SUBJECT **Permit Amendment Request**
Columbia-Colebrook, #42313
(DES#2020-01554)

Re: Notice of Proposed Amendment to NHDES Wetlands Permit
Existing Permit Number: 2020-01554
Columbia-Colebrook, 42313 – NH Route 3 over Simms Stream

**Attachment C.
Revised Plans**

US ROUTE 3 OVER SIMMS STREAM

STATE OF NEW HAMPSHIRE				
DEPARTMENT OF TRANSPORTATION • BUREAU OF HIGHWAY DESIGN				
WETLAND IMPACT PLAN COLUMBIA				
SHEET SCALE	DGN	STATE PROJECT NO.	SHEET NO.	TOTAL SHEETS
1" = 20'	42313WetPlans	42313	5	8

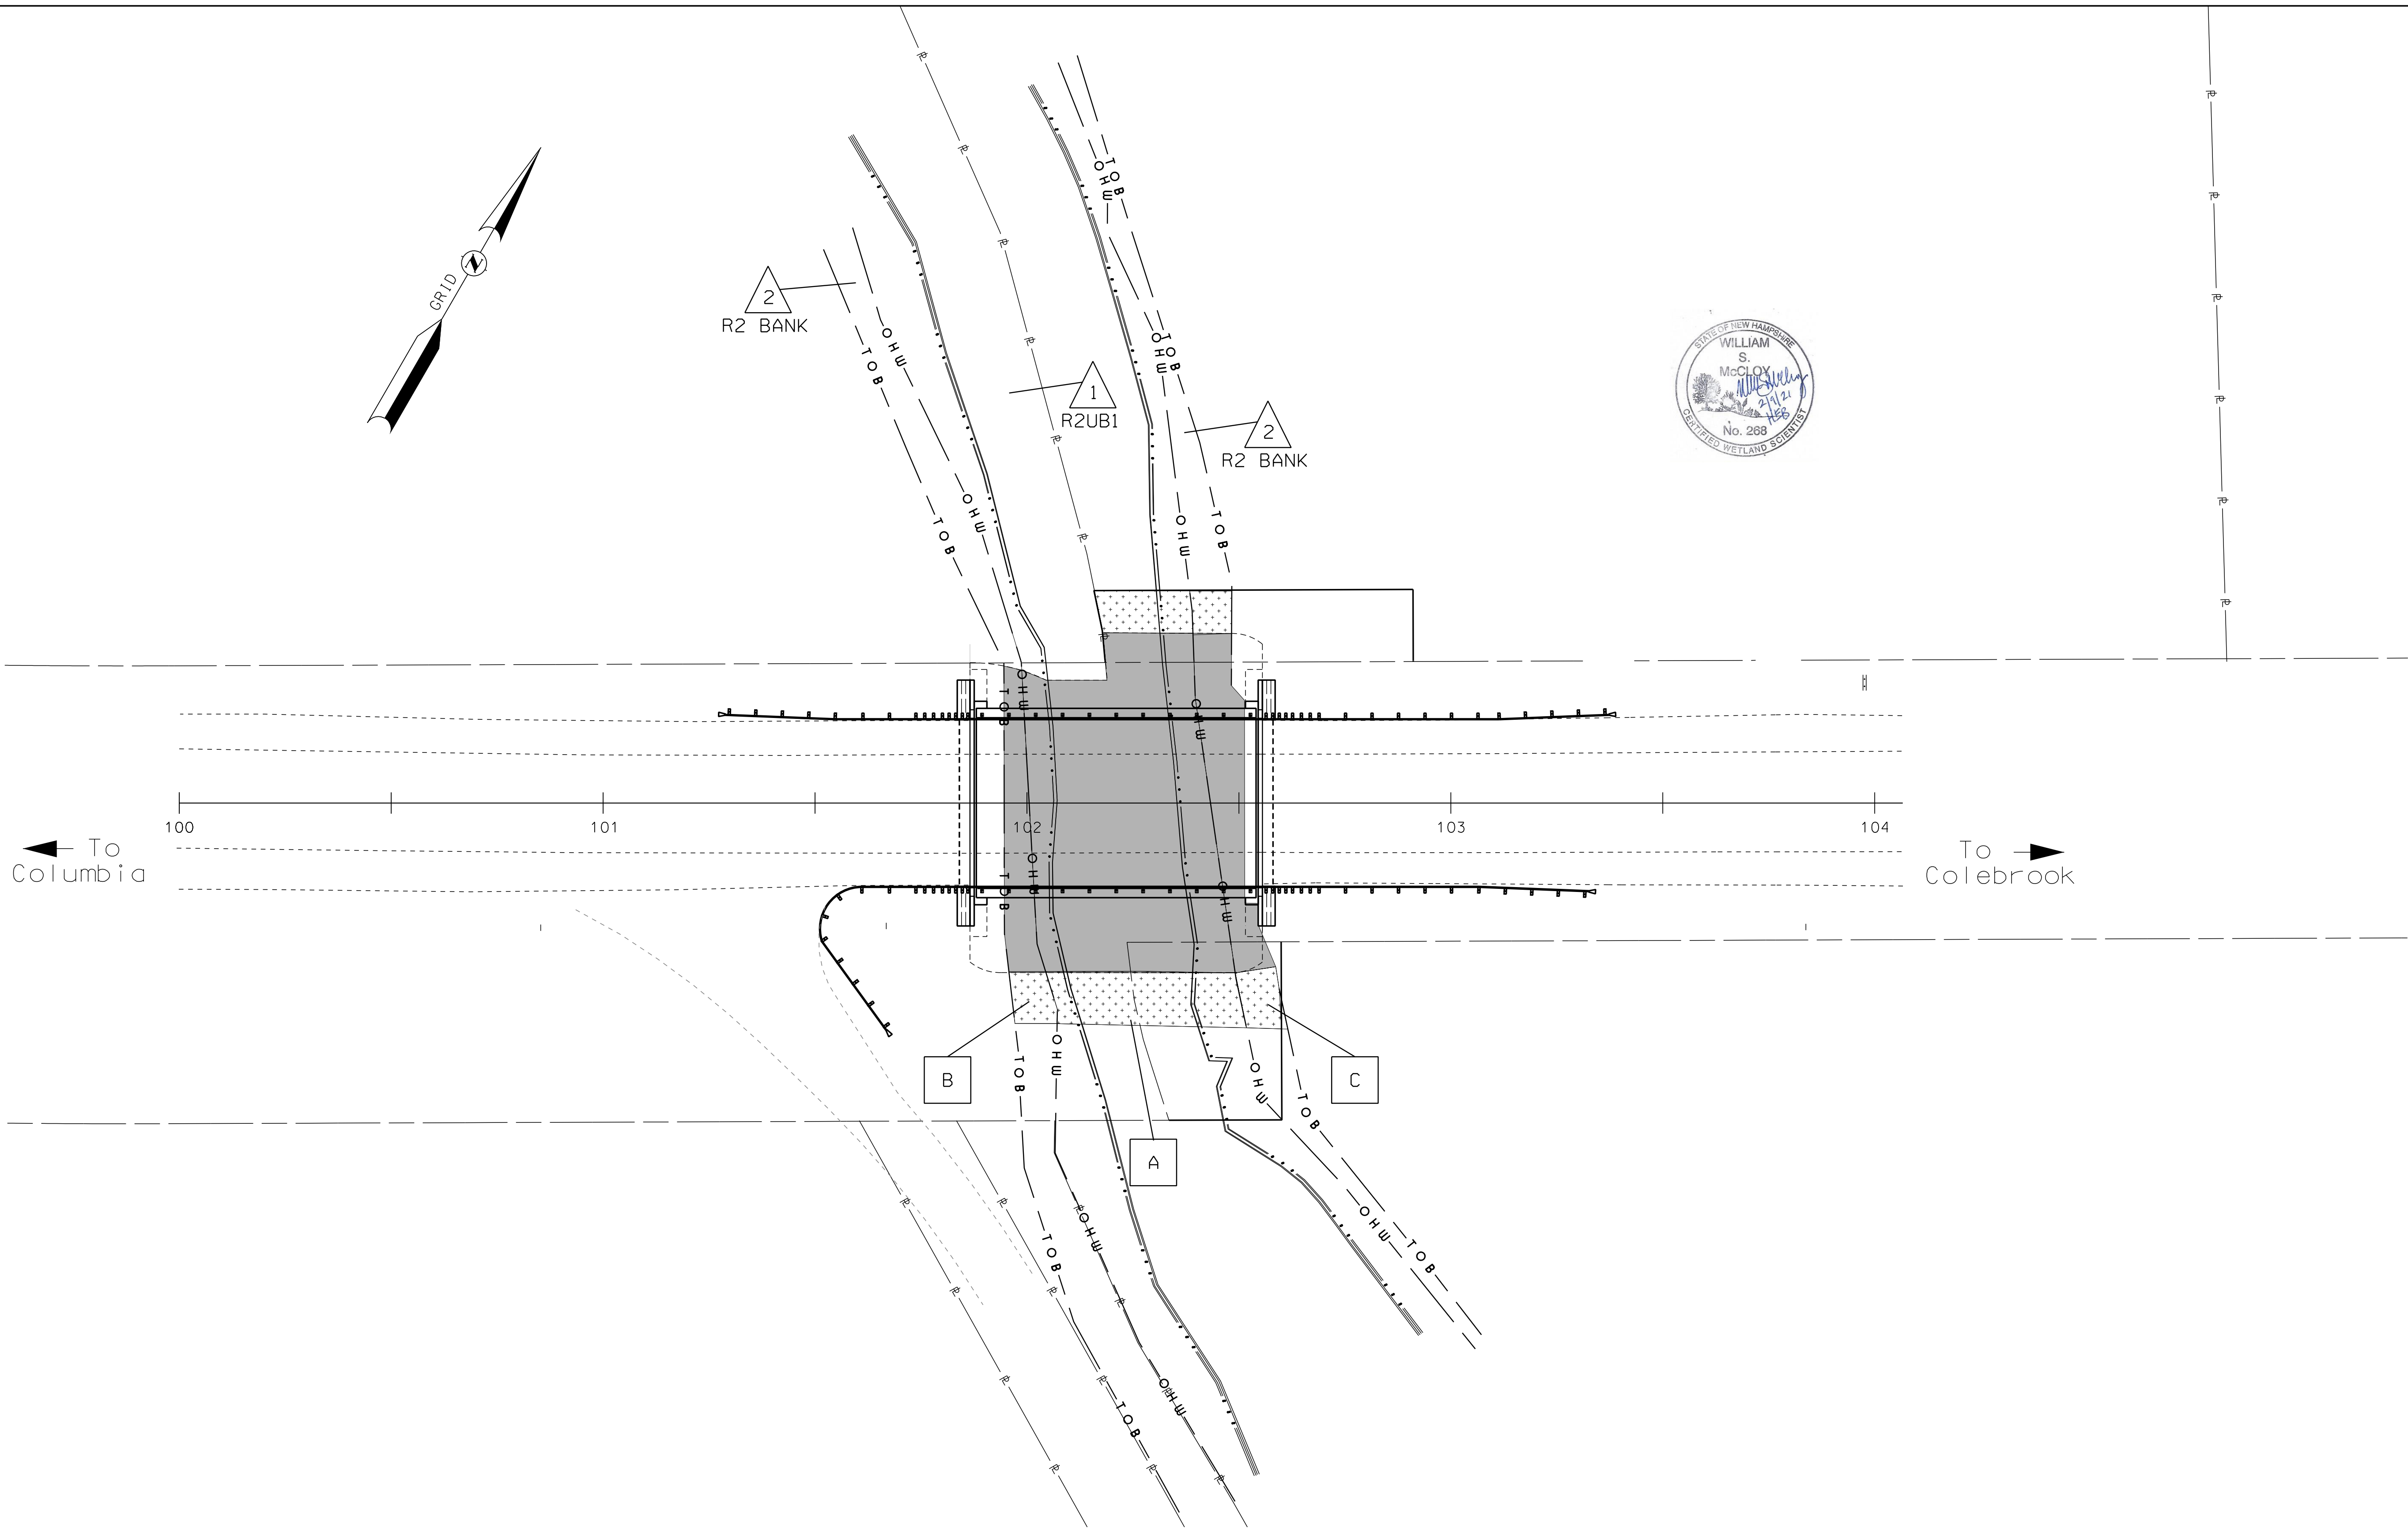
The project footprint and impacts have been reduced because an easement granting access to a portion of the project area for construction, including a portion of the bank and bed of Simms Stream, was not able to be obtained from the landowner. The area is located in the southwest corner of the project area. This easement had been assumed as part of the original application and subsequent response to a RFMI. An "Amendment Request Form for a Wetlands Application or Permit" (Form NHDES-06-081) is included in Attachment A.

Impacts to Simms Stream will be reduced as a result of the constricted project area. The originally proposed impacts and revised impacts are included in Table 1, below, and an updated Page 5 of the Standard Dredge and Fill Wetlands Permit Application including Section 12 – Impact Area (Env-Wt 311.04(g)) is included for reference in Attachment B. Revised plans are provided in Attachment C.

Proposed permanent impacts to Simms Stream have been reduced by 249 SF (and 10 LF) and proposed temporary impacts have been reduced by 348 SF (and 10 LF). No changes are proposed to the scale and nature of the remaining channel and bank stabilization measures and their associated impacts.

The change in design reduces total impacts to 5,455 SF (4,320 SF permanent and 1,135 SF temporary).
